AGENDA

La Vergne Planning Commission

January 30, 2024 at 6:00 PM

REVISED:	
DRAWN: SJA/CFB3	
DATE: 12-29-2023	
CHECKED: MAT	
FILE NAME: 19258phase1	
SCALE: 1"=50'	
JOB NO. 19258	
SHEET: C0.4

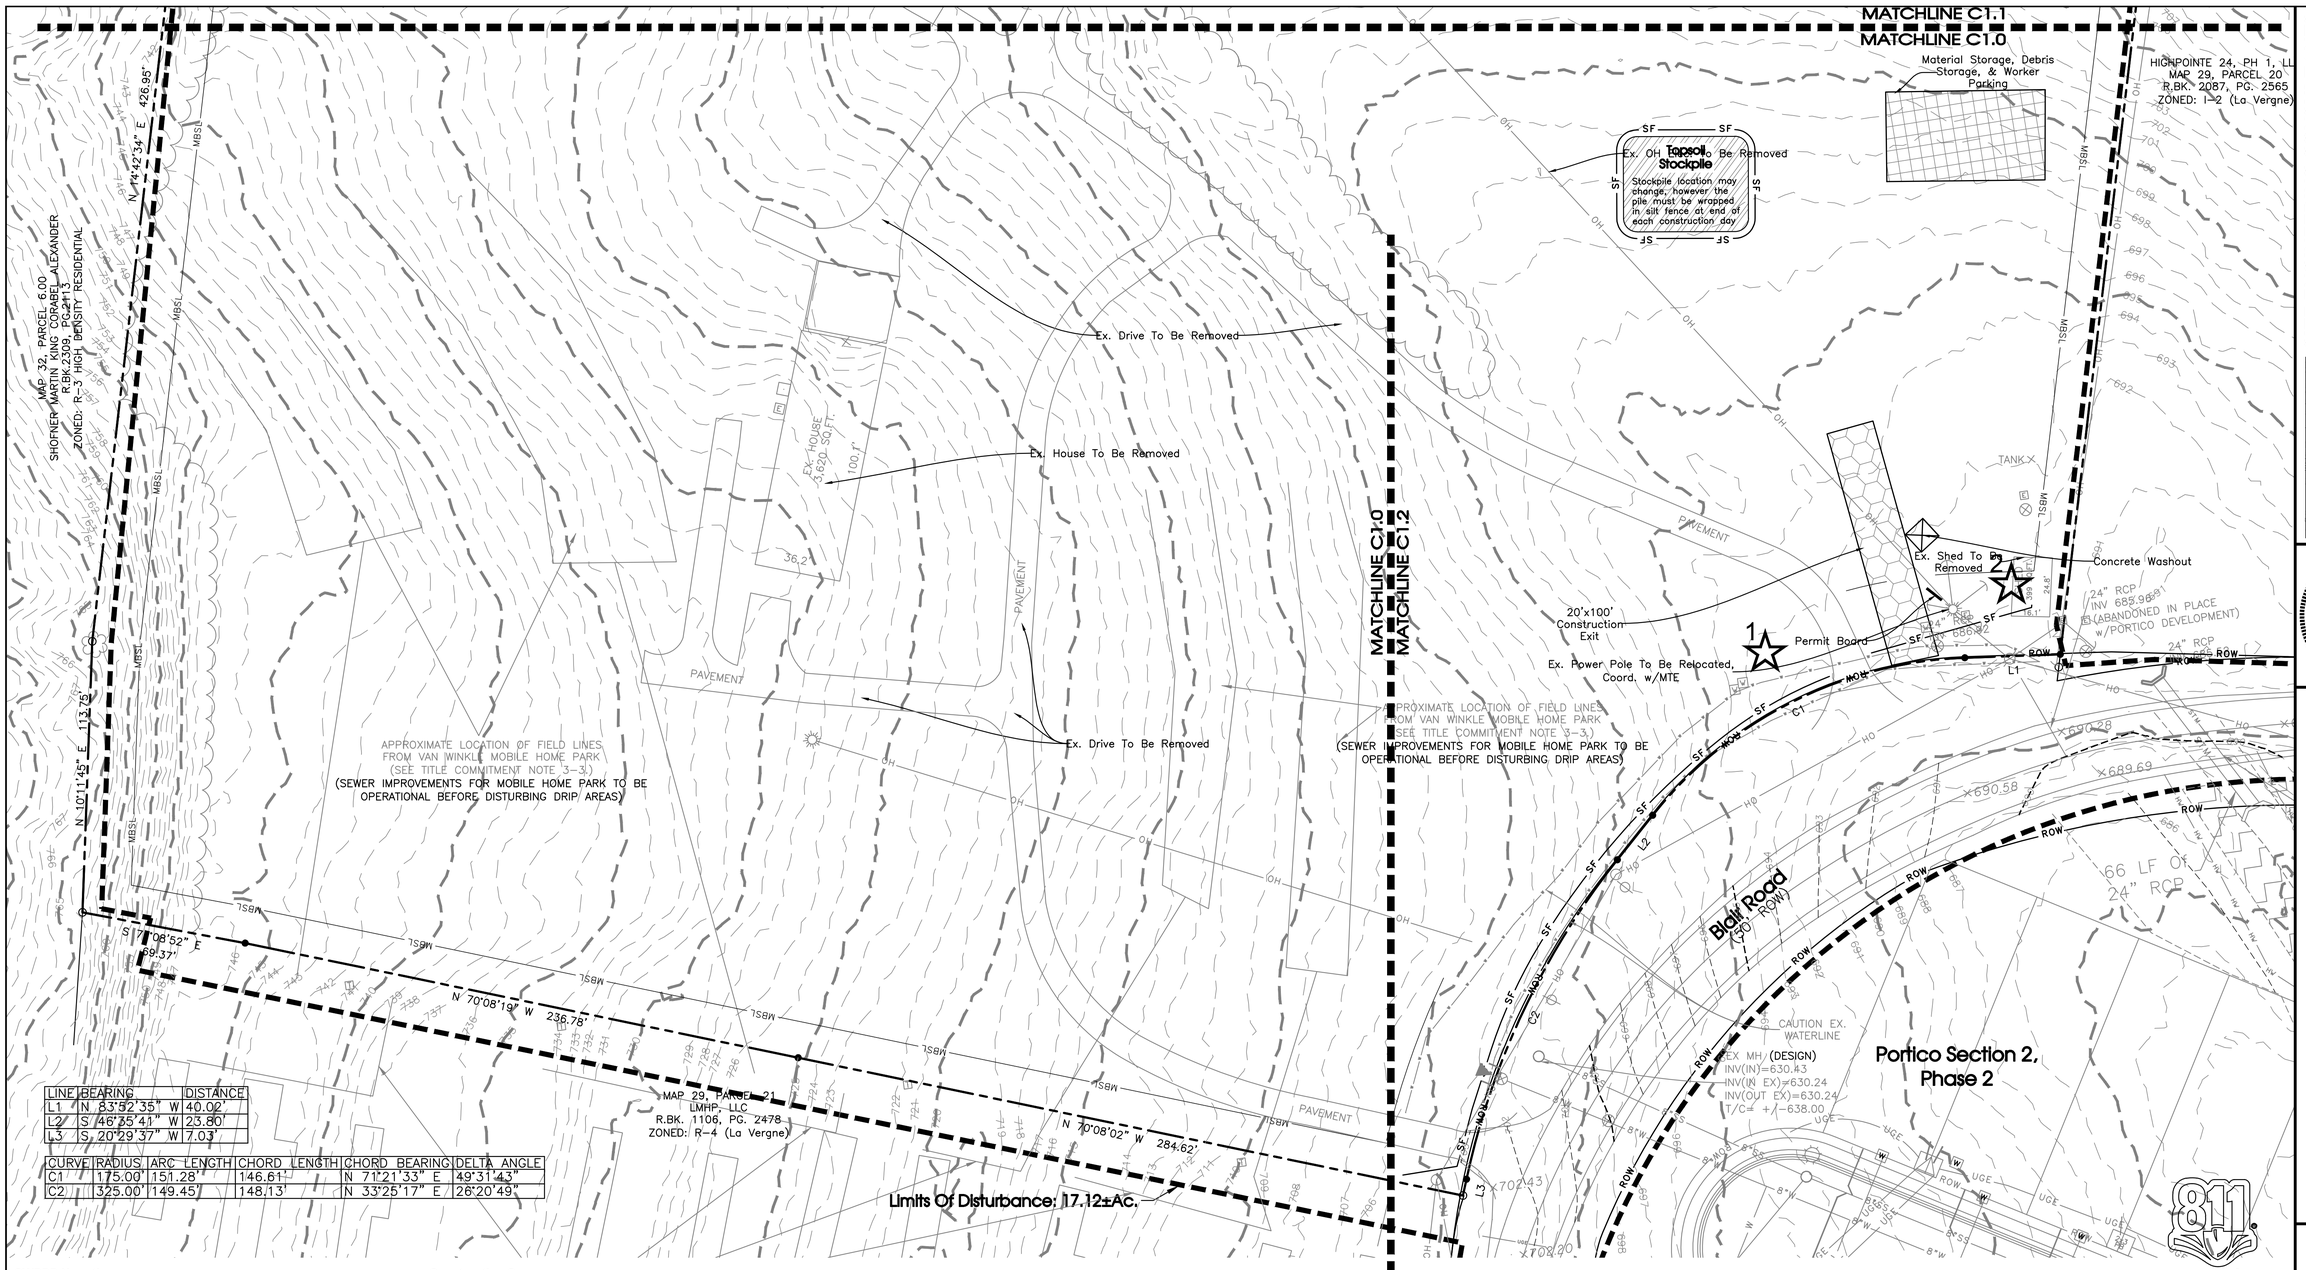
14.(C0.3) Fire hydrants shown along Shelf Lane appear to be about 600 feet apart. Coordinate with the Fire Marshal.
15. (C0.4) Buildings A, I, K, L, M, and O do not show an obvious clear, flat location for the placement of a transformer which might result in transformers being placed in sales or other non-preferred locations. Provide a clear, flat location where a transformer might be placed. It is understood that the developer does not have complete control over the electrical utility.

REVISED:
DRAWN: SJA/CFB3
DATE: 12-29-2023
CHECKED: MAT
FILE NAME: 19258phase1
SCALE: 1"=30'
JOB NO. 19258
SHEET: C1.0

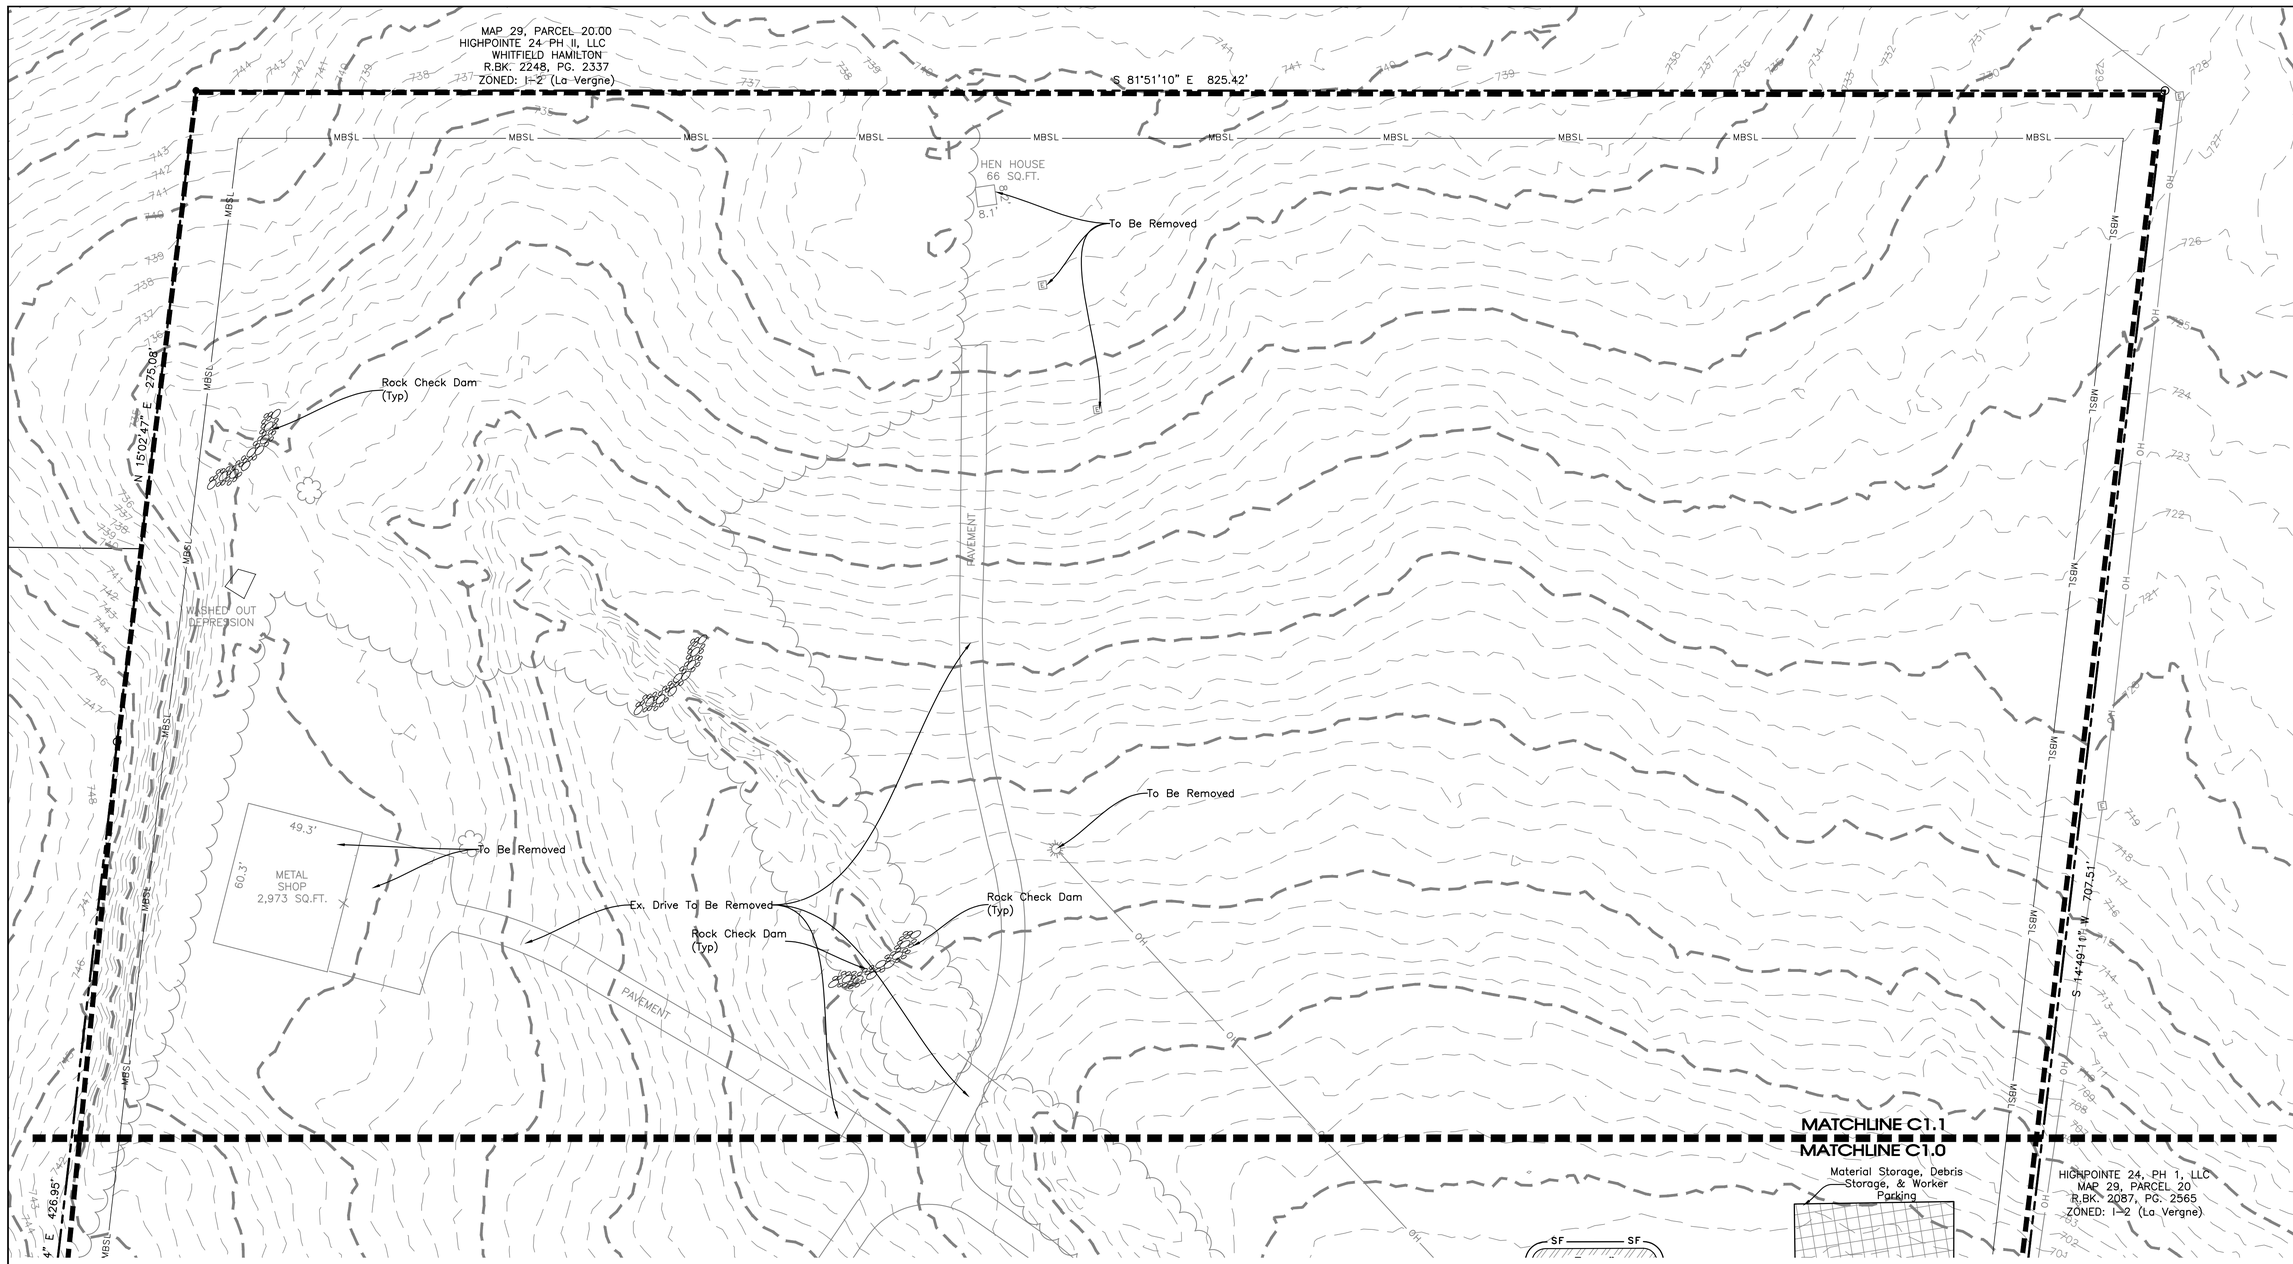
19. (C1.0) Plan states "24" RCP abandoned in place with Portico development." and the existing 24" culvert presently has no outlet. THIS IS INCORRECT. The approved Portico Place Section 2 plans call for that culvert to be extended and to remain functional. Portico Place Section 2 will not be accepted by the city until both of the culverts are functional as shown on the approved Portico Place Section 2 plans. Show this correctly on sheet C1.0 and also account for both culverts in the drainage plan and calculations requested under items 9, 17, and 18 herein.

REVISED:
DRAWN: SJA/CFB3
DATE: 12-29-2023
CHECKED: MAT
FILE NAME: 19258phase1
SCALE: 1"=30'
JOB NO. 19258
SHEET: C3.0

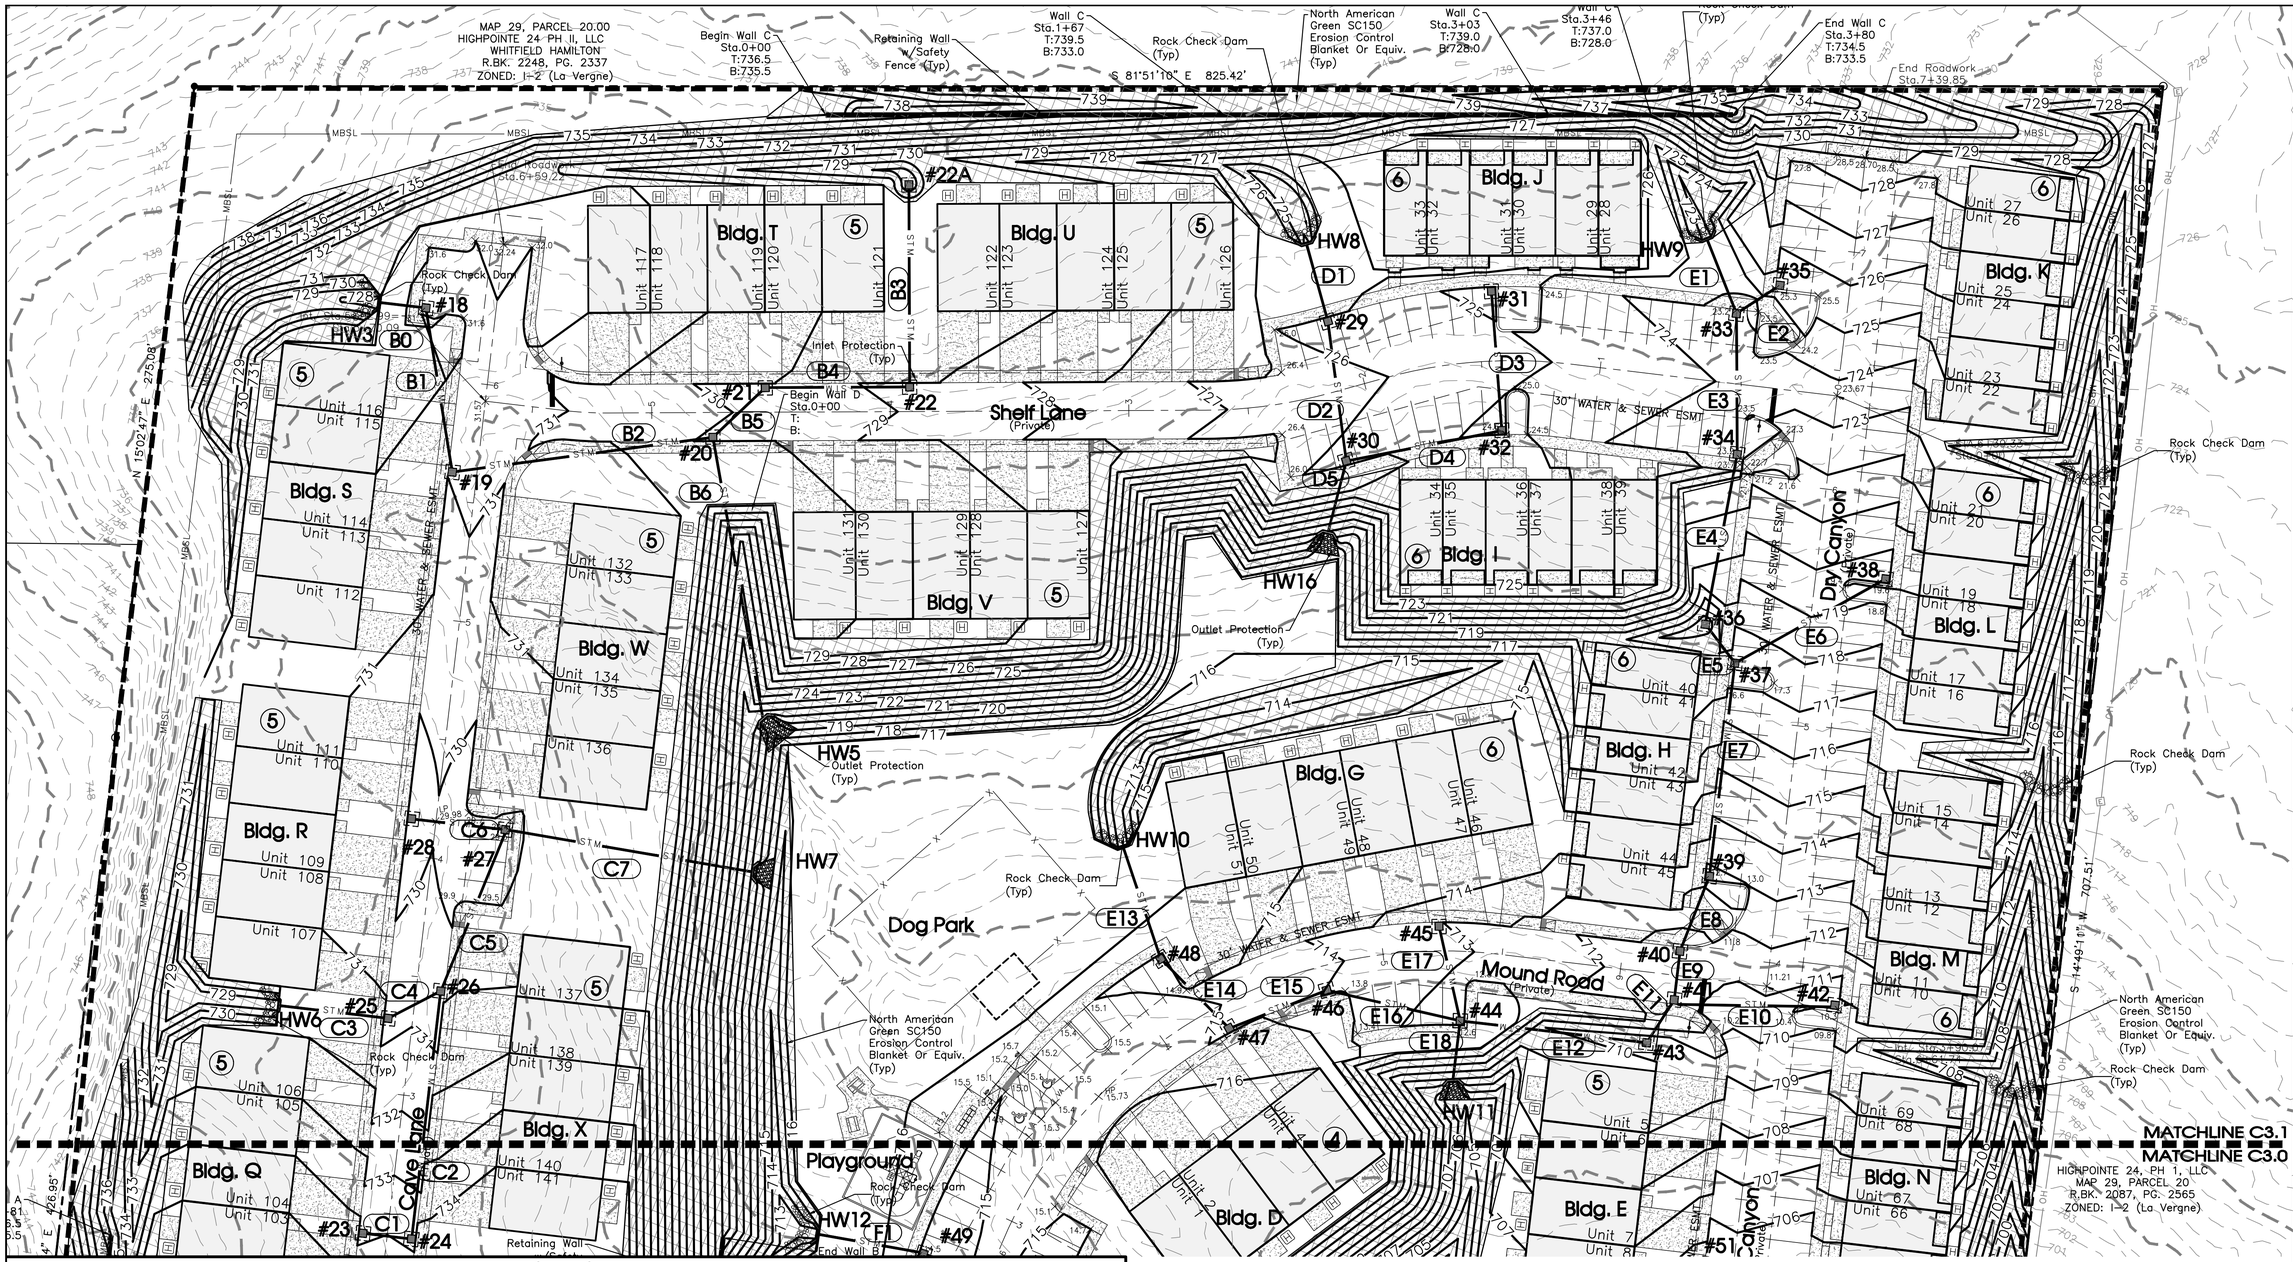
10. (Detention Calculations) Detention calculations are in compliance with City Stormwater Management Ordinance adopted in 2023.
11. (C3.0) Provide depths of stormwater pipes within Blair Road right-of-way. These are pipe runs 57 to 58, 58 to 59, 60 to 59, and 59 to 61.

12. (C3.0, C3.0) Renumber second sheet C3.0 to C3.1
13. (LTMA and LTMP) Modify the LTMA and the LTMP to clarify that the portions of the private stormwater system which are located within the Blair Road ROW (inlets 57, 58, 59, 60, and 61 as well as the pipes connecting them) are the responsibility of the owner of Blair Ridge as listed in the LTMA.

17. (C3.0) Provide construction details for extension of culvert(s) under Blair Road including HW 17 and Structure #60.
18. (C2.4) HW 17 is called out as a headwall outlet. It appears to be a headwall inlet.
